Access Compliance Report

Public Rights-of-Way

Intersection ID: 49294	Main Street: ELIZABETH_CREST_LN	Cross Street: CREEKSIDE_PARK_RD	Location: SW
ADA ID: 67025AAD4188	Ramp Type: Perp	Initial Pass/Fail: Fail	Overall Compliance: No
Codes/Mitigation Info/Possible Solution		Field Measurements/Component Compliance	
Severity Score: 26.25

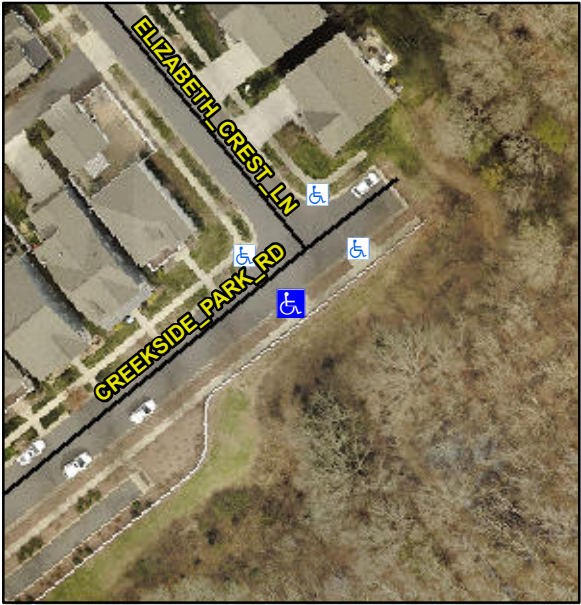
Possible Solutions:	Compliance	Description	Data	Compliance	Description	Data
	Remove & Replace Entire Ramp.	N/A	Ramp Length (in)	72.0	No	Ramp Slope (%)	13.2
		Yes	Ramp Width (in)	48.0	No	Ramp XSlope (%)	2.4
		N/A	Flare Type LT	N/A	N/A	Flare Type RT	N/A
		N/A	Flare Slope LT (%)	N/A	N/A	Flare Slope RT (%)	N/A
		N/A	Flare Traversable LT?	N/A	N/A	Flare Traversable RT?	N/A
		N/A	Landing Length (in)	N/A	N/A	DWS Provided?	N/A
		N/A	Landing Width (in)	N/A	N/A	DWS Contrast?	N/A
		N/A	Landing Slope (%)	N/A	N/A	DWS Length (in)	N/A
		N/A	Landing X Slope (%)	N/A	N/A	DWS Full Width?	N/A
<p>Surveyor Notes:</p> <p>N/A</p> <p>PROW/ADA:</p> <p>Not Found, R304.2.2, R304.5.3</p>		N/A	Landing Curb? (Y/N)	N/A	N/A	DWS Offset (in)	N/A
		N/A	Shared Landing?	N/A			
		N/A	Gutter Ponding?	N/A	N/A	Gutter Slope (%)	N/A
		N/A	Gutter Lip Ht (in)	N/A	N/A	Gutter X Slope (%)	N/A
		N/A	Painted X Walk1?	No	N/A	Painted X Walk2?	N/A
			X Walk 1 Direction	To NW		X Walk 2 Direction	N/A
